# Work Order ID 107780

Item Name: Crosstube Assembly, Mid Fwd

<b>DART AEROSPACE LTD</b> HAWKESBURY, ONTARIO, CANADA	
DRAWING NO. D206-667-147	REV. A SHEET 1 OF 4
TITLE CROSSTUBE ASSY (206L MID FWD)	SCALE NTS
COPYRIGHT © 2010 BY DART AEROSPACE LTD THIS DOCUMENT IS PRIVATE AND CONFIDENTIAL AND IS SUPPLIED ON THE EXPRESS CONDITION THAT IT IS NOT TO BE USED FOR ANY PURPOSES OR COPIED OR COMMUNICATED TO ANY OTHER PERSON WITHOUT WRITTEN PERMISSION FROM DART AEROSPACE LTD.

DRAWING NO. D206-667-147	TITLE CROSSTUBE ASS'Y (206L MID FWD)	REV. A	DART AEROSPACE LTD ENGINEERING ORDER		D.E.O. NO. D206-667-147-A-1	SHEET NO. SHEET 1 OF 1	SCALE NTS
DRAWN 97	CHECKED ADS	MFG. APPR. JB	APPROVED MD		DE APPR. H		
DATE 11.07.15	DATE 11.07.20	DATE 11.07.21	DATE 11/07/21		DATE 11.07.21

**DETAIL P**  
BONDING STRAP INSTALLATION 2 PL

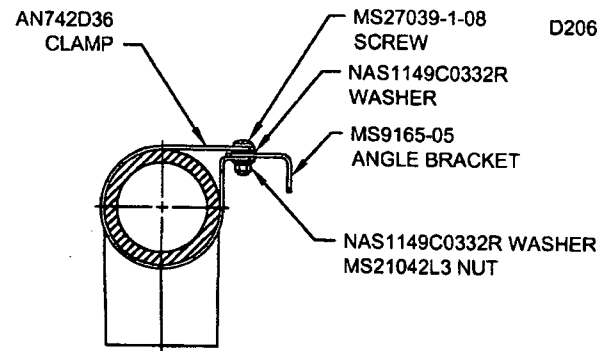
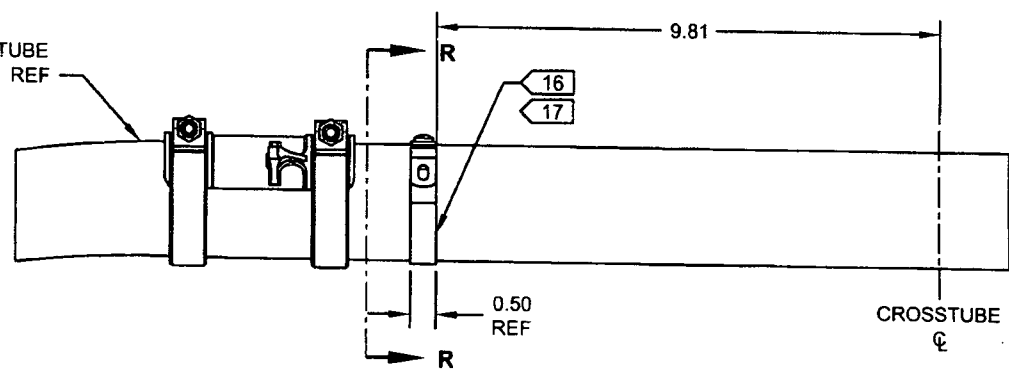
ADD ELECTRICAL GROUNDING STRAP

ADD

- 16) MASK AREA UNDER CLAMP PRIOR TO PAINTING
- 17) SEAL EDGES WHERE AN742D36 CLAMP MEETS WITH THE CROSSTUBE USING SIKAFLEX-241/-291 OR MIL-S-8802 CLASS B2 OR PROSEAL 890 SEALANT
- 18) PERFORM RESISTANCE CHECK TO ENSURE MAX RESISTANCE IS 10 MILLIOHMS

ITEM	QTY	PART NUMBER	DESCRIPTION
1	X	D206-667-147	CROSSTUBE ASSEMBLY (206L MID FWD)
⚡			
10	2	AN742D36	CLAMP
11	2	MS9165-05	ANGLE BRACKET
12	2	MS21042L3	NUT (OR MS21042-3)
13	2	MS27039-1-08	SCREW
14	4	NAS1149C0332R	WASHER (OR AN960C10L)
